RESPONSE TO REQUEST FOR ADDITIONAL INFORMATION

APR1400 Design Certification

Docket No. 52-046

RAI No.: 248-8295
SRP Section: 03.08.05 - Foundations
Application Section: 3.8.5
Date of RAI Issue: 10/14/2015

Figure 3.8-57 Rebar Arrangement of Containment Dome

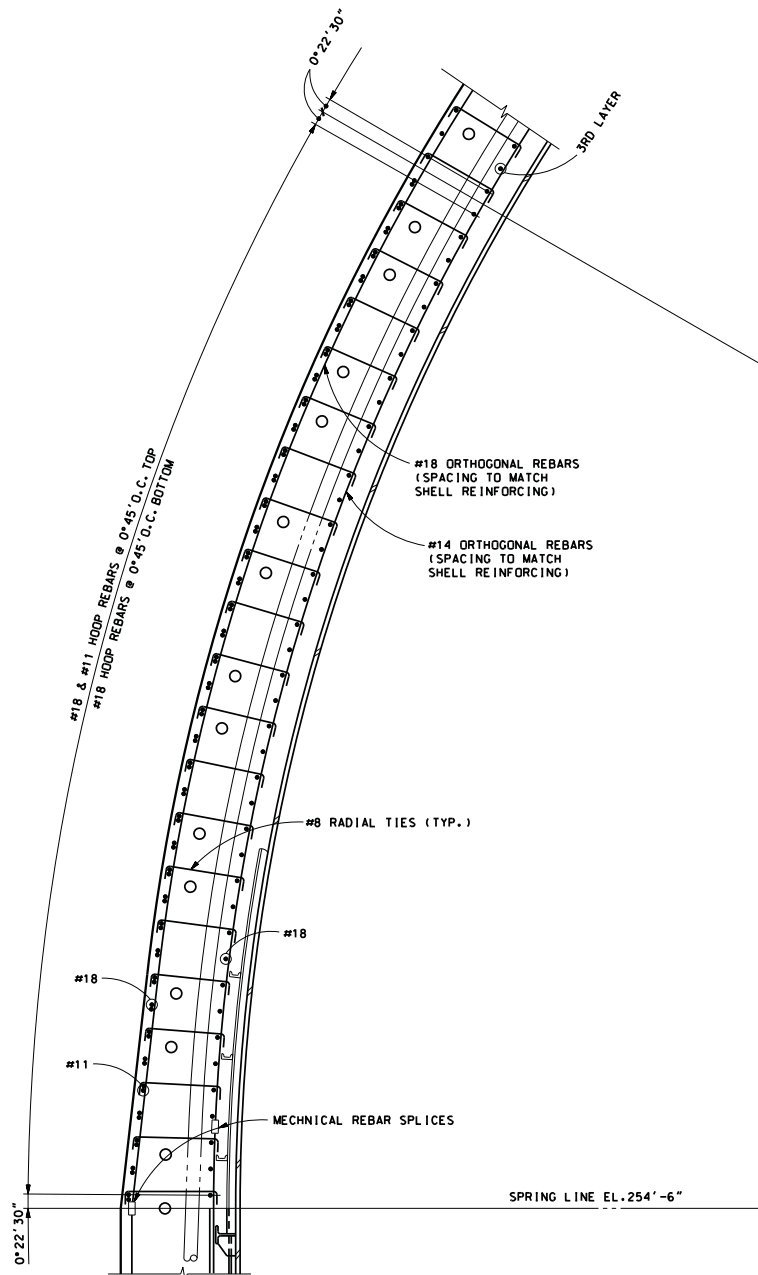
- a. Whether any other critical sections such as the dome; steel plate liner to the containment; floor slab between the SSW and the containment, and a steel beam and/or column; and mainsteam and feedwater penetrations are identified as critical sections. If so, the applicable portion of the DCD should be updated accordingly.

Practically, there is no concrete or steel column in the reactor containment building, and steel beams are out of scope for the APR1400 standard design. In the list of critical design sections in DCD Tier 2, Section 3.8A.1.4.1.3.5, containment dome and liner plate are missing. For the containment liner plate, the design procedure and criteria are described in Section 3.8.1.4.10, and the design results, including the margin of safety, are presented in Table 3.8-12 in the DCD.

Accordingly, Sections 3.8A.1.4.1.3.4 through 3.8A.1.4.1.3.7, and Tables 3.8A-2 and 3.8A-3 will be modified, and Figure 3.8A-57 will be added for the missing items, as shown in Attachment 1 to this response.

The containment dome is also reinforced by two-way orthogonal sets of vertical reinforcing steel and hoop reinforcing steel. The orthogonal reinforcing is the continuation of the vertical reinforcing in the containment wall. Hoop reinforcing is also provided up to 45 degrees above the springline. Radial reinforcements are provided over the entire dome to resist radial tension forces resulting from curved tendons.

Figure added
